**STAFF RECOMMENDATION**  
**119 and 121 3<sup>rd</sup> Avenue South**  
**August 18, 2021**

**Application:** New Construction—Addition  
**District:** Broadway Historic Preservation Zoning Overlay  
**Council District:** 19  
**Base Zoning:** DTC  
**Map and Parcel Number:** 09306403000 and 09306403100  
**Applicant:** Stewart Dorn, Remick Architecture  
**Project Lead:** Melissa Baldock, melissa.baldock@nashville.gov

<p><b>Description of Project:</b> Applicant proposes two rooftop additions; one over 119 3<sup>rd</sup> Avenue South and one over 121 3<sup>rd</sup> Avenue South.</p> <p><b>Recommendation Summary:</b> With the condition that staff approve all final material choices prior to purchase and installation, staff finds that the proposed rooftop additions meets Section III. of the design guidelines for the Broadway Historic Preservation Zoning Overlay.</p>	<p><b>Attachments</b> <b>A:</b> Site Plan <b>B:</b> Elevations</p>
--	--

A103

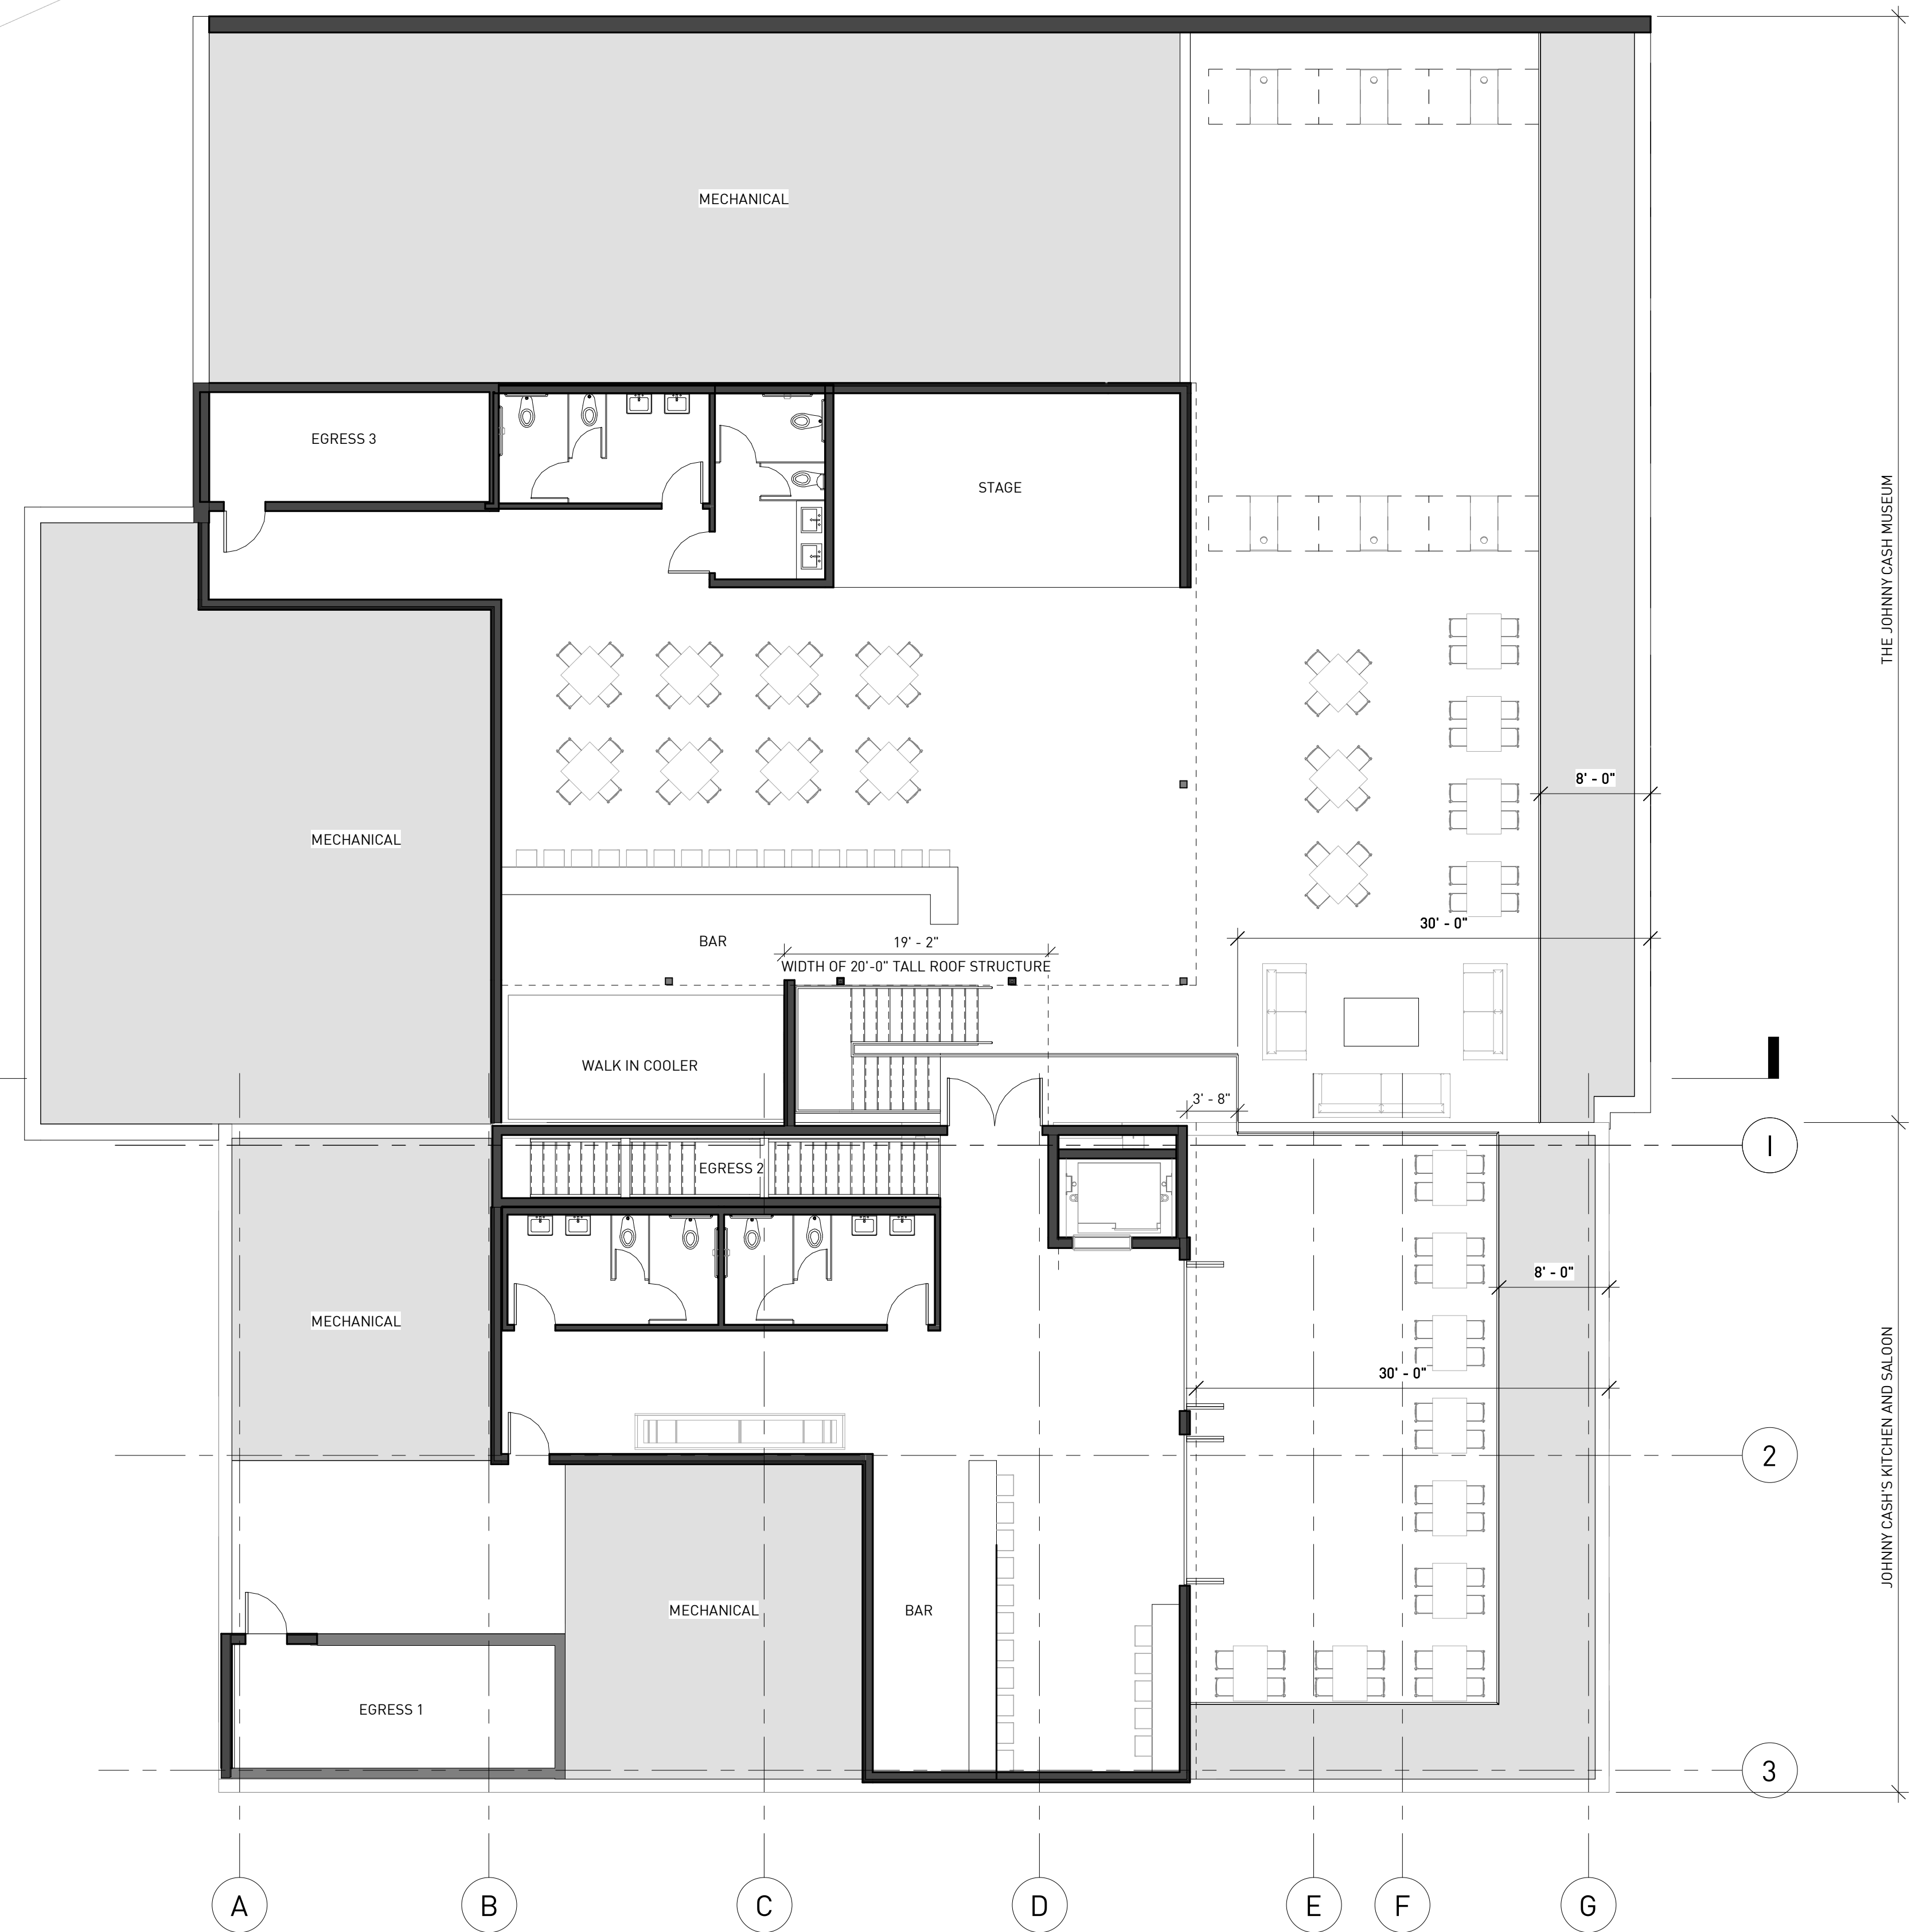
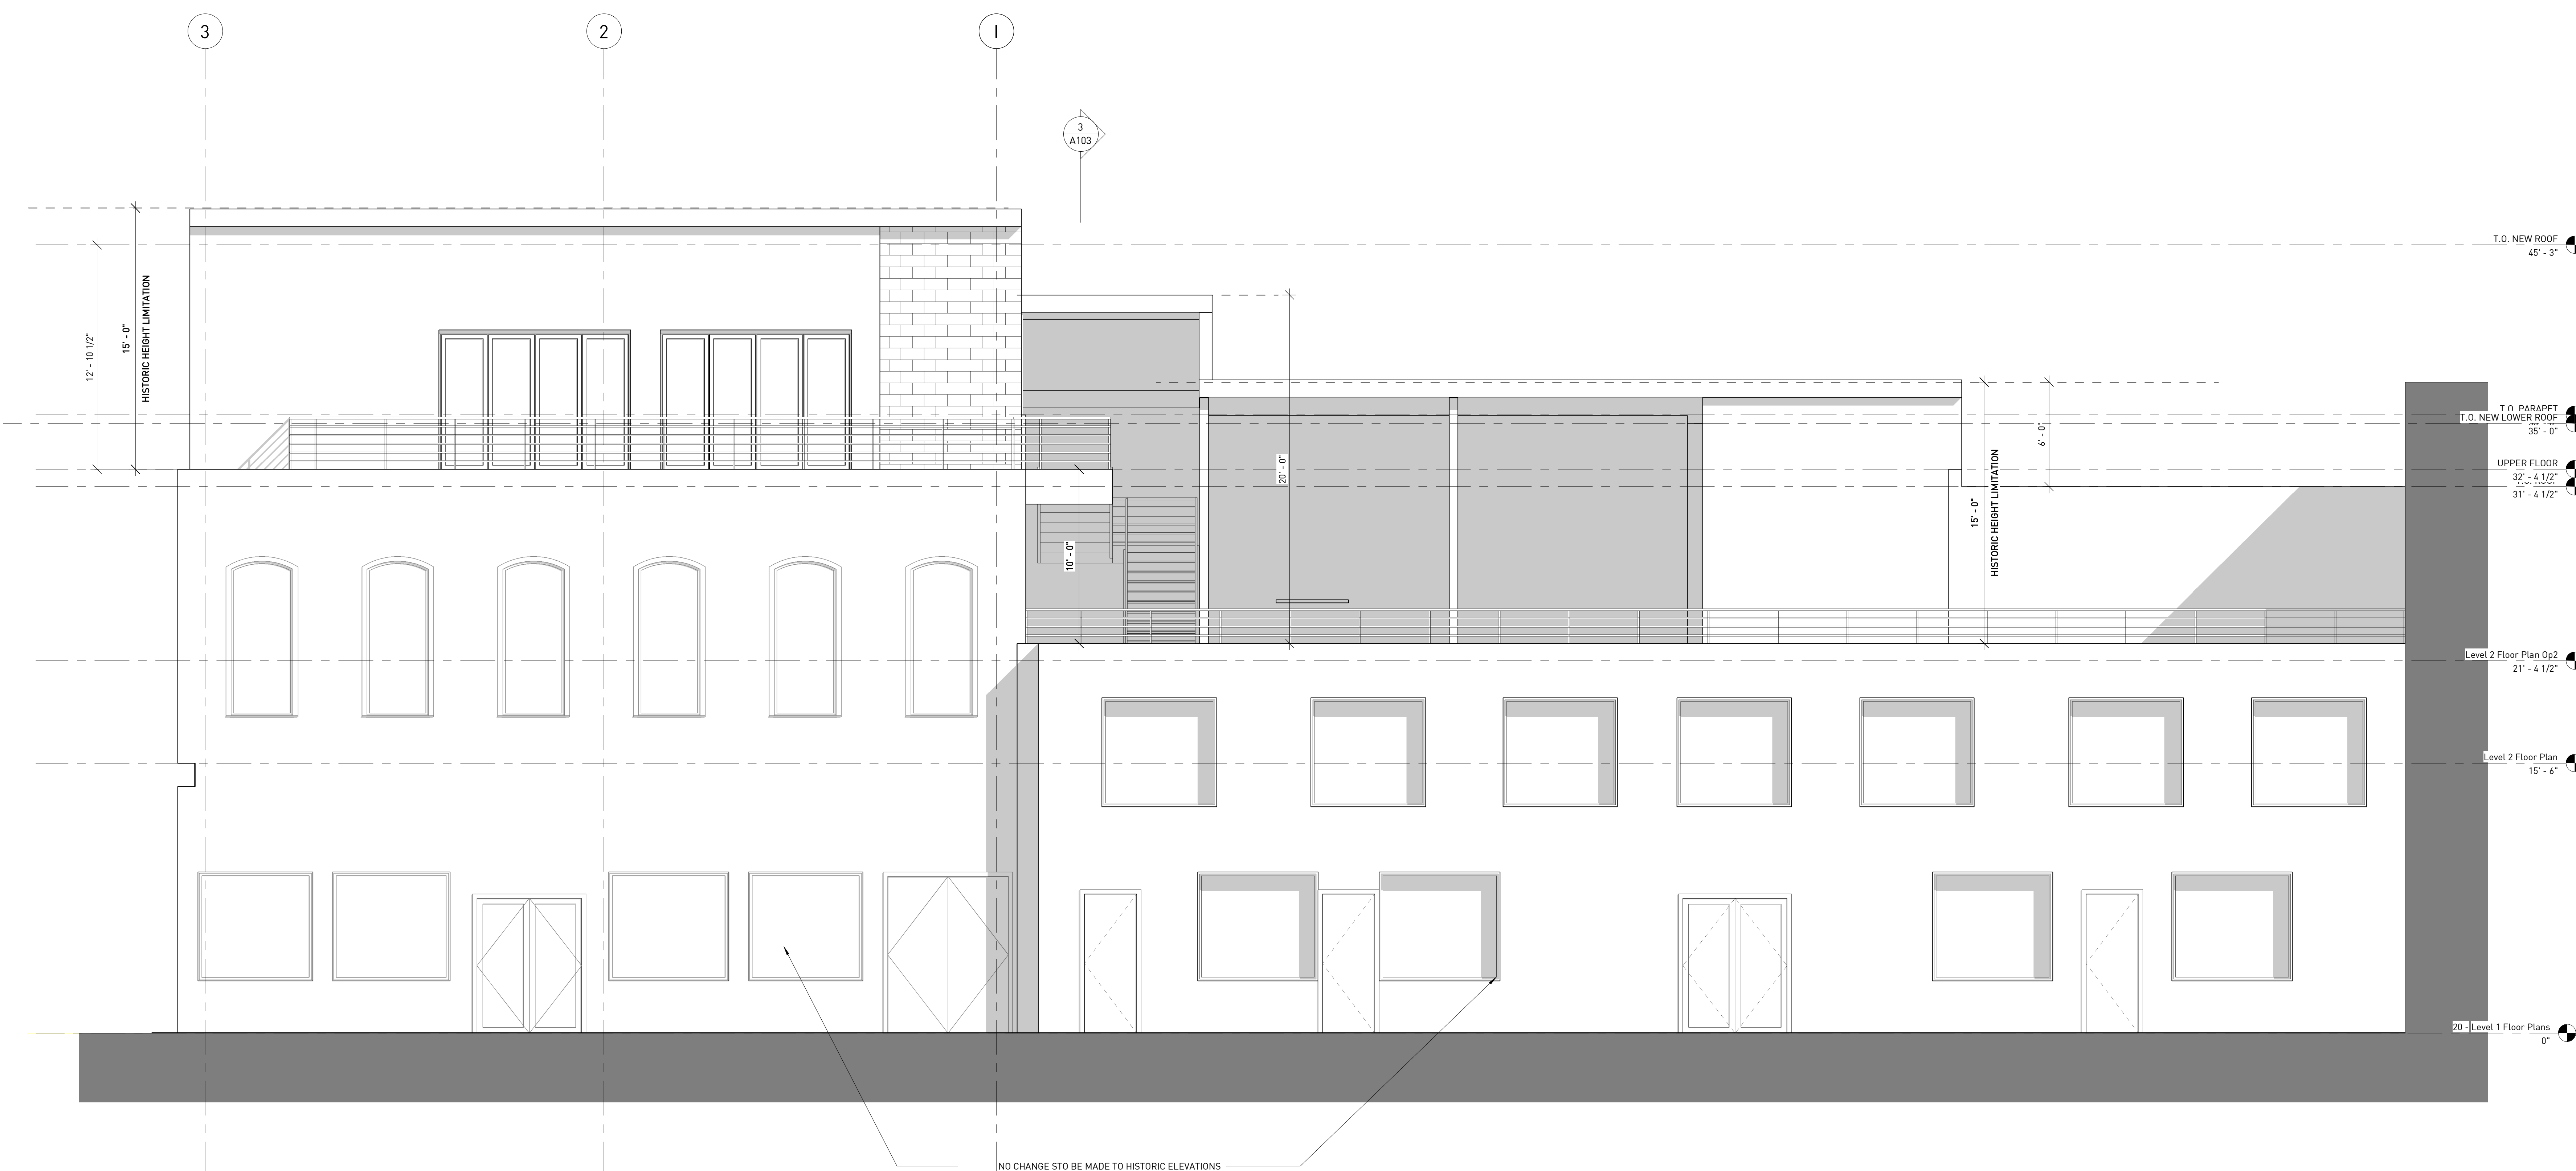
The project includes rooftop railings that are stepped back at least 8' from the front wall.

Materials: The materials for the rooftop structure and railings have not yet been determined, but the applicant indicated that they will be largely steel and glass. Staff finds that these materials would be appropriate for a rooftop addition but recommends approval of all final material choices prior to purchase and installation in order to ensure they meet Section III.G. of the design guidelines.

**Recommendation Summary:** With the condition that staff approve all final material choices prior to purchase and installation, staff finds that the proposed rooftop additions meets Section III. of the design guidelines for the Broadway Historic Preservation Zoning Overlay.
